INDESIT company

Model type:
AVL129EU

Commercial code:
F029841

n1040325: New shock absorber fixing system with pin

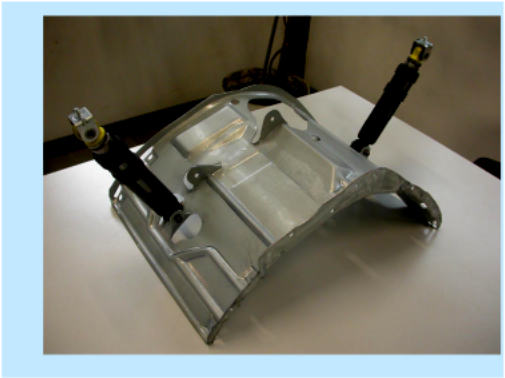
From serial no. 40427.0001, shock absorbers have been fixed to the tank unit cradle with two 11 mm pins code C00110163 (see fig. 01 and 02 enclosed) in place of the 8 mm screws code 093750 and relevant locking nuts code 030443, on all washing

machines and dryers produced in the Comunanza factory.
The items affected by this modification are:
1) The cradles have the same Service code, as they can be used in place of the new ones after widening the shock absorber fixing holes to a diameter of 10 mm.
Code 093848 - Tank unit cradle 46 lt
Code 093878 - Tank unit cradle 40 lt.
2) The new shock absorbers, with fixing bushing having no s/steel spacer, are not managed as they are interchangeable with the premodified items (make sure they are CIMA type, as the managed items), fixed with M8 screws code 093750 and related locking nut code 030443 (see figs. 05 and 06).
Code 093884 - Shock absorber 80 N
Code 093885 - Shock absorber 100 N

To remove the shock absorber from the tank, first extract the pin with a few hammer taps (see fig.03) until it is aligned with the tank bracket and then pull it out with a pair of pliers (see fig. 04).
(To refit the shock absorber use a new pin. Insert the pin until the toroidal edge is aligned with the bracket.)

Fig. n10402231

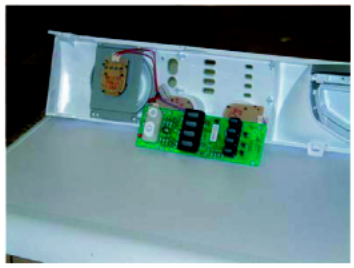
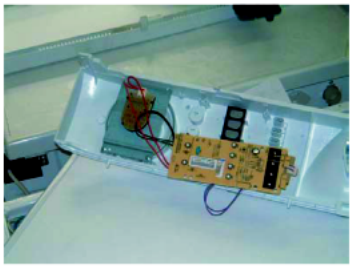
From serial no. 40429.0001, models AVL, AVXL, AVSL, AML have been equipped with a new panel with well holes for the ON/OFF and RESET buttons and flush plastic light diffusers in place of the projecting siliconed ones (see picture n10402231

Fig.02). These features determine whether an appliance is modified or premodification.
The modification has also involved the electronic card whose panel and display communication connectors are on the left and not at the back (see picture n10402232 Fig.2).

For both models
C00143338 - LED CARD EVOII AVL /BUILT-IN ARISTON
C00110115 - WHITE BUTTONS ON-OFF/RESET EVOII LED KIT
C00109854 - PANEL WIRING LBE EVOII
C00110055 - SILICONED BUTTONS AVL-AVSL
C00110059 - PANEL WIRING -DISPLAY 240000848B2.
C00111227 - WIRING MAIN - DISPLAY 24000084804B1 (POLARIZED).
The new parts are only interchangeable with the pre-modification ones if used altogether. They are not individually interchangeable.

Fig . 001

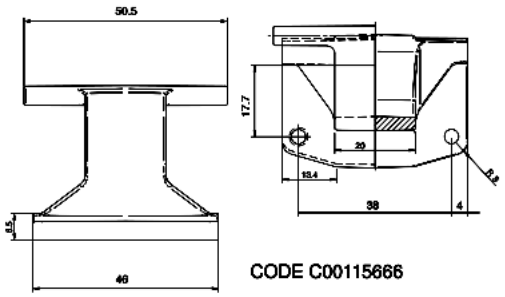
From serial no. 50207.0001, all Ariston models produced in the Teverola factory (see table 001 attached) with industrial code (given on the rating plate) starting with 46, have been equipped with a Zamac hinge with 150° opening angle, code C00115666 (see Fig.001).
This modification has involved the introduction of the following items:

Code C00115670 - Complete door EVOII 150° white 27 with standard glass;
Code C00115674 - Complete door EVOII 150° white 27 with long glass;
Code C00115667 - EVOII body for 150° hinge white 27;

The premodified items are not interchangeable separately with the modified ones.

Code C00110133 - Complete door EVOII Standard 180° white 27 standard glass;
Code C00092157 - Complete door EVOII 180° white 27 long glass;
Code C00096193 - EVOII body for 150° hinge white 27;

n4008f00: Thermic link wire removed on three-phase motor

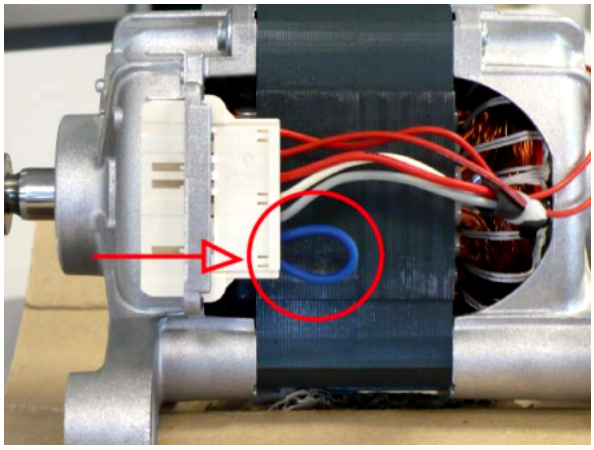
Attention!
When you assist the premodification models using the new motor code you MUST use the thermic link wire code C00265838.

In the attached image you can see the fixing of thermic link wire in the motor therminal box.
